MUL-T-LOCK®

NO. 213

Improvements to the Drawer Bolt Lock

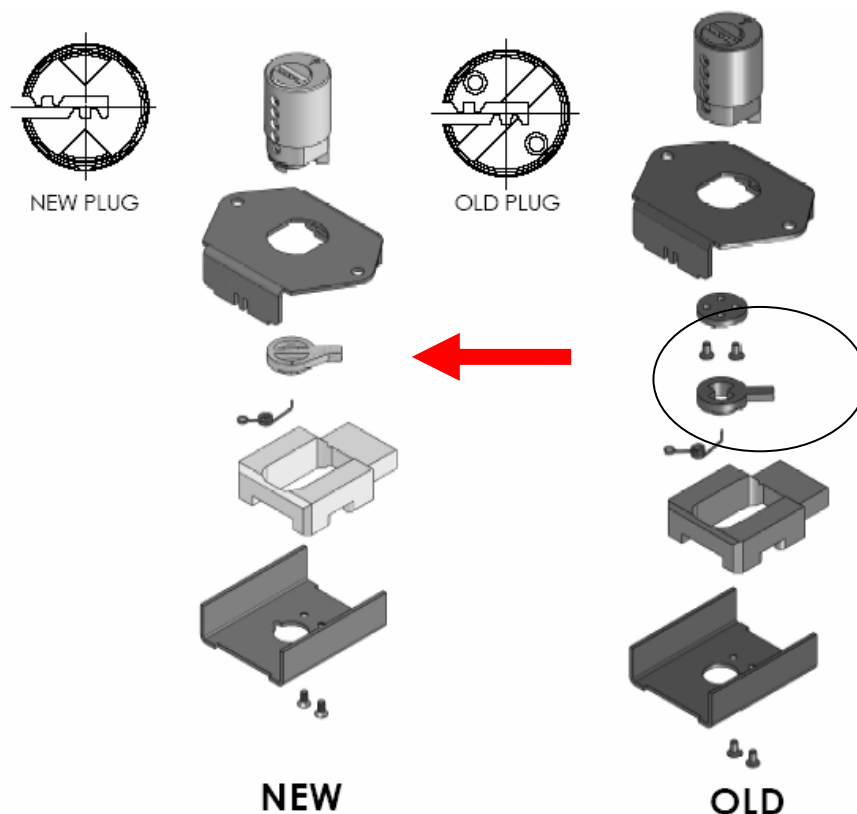
The plug was changed, and with it the bolt actuator – this change eliminates the use of the plug disc, no change to other parts!

Due to this change – plugs are not interchangeable (between old & new) as can very clearly be seen in the drawing.
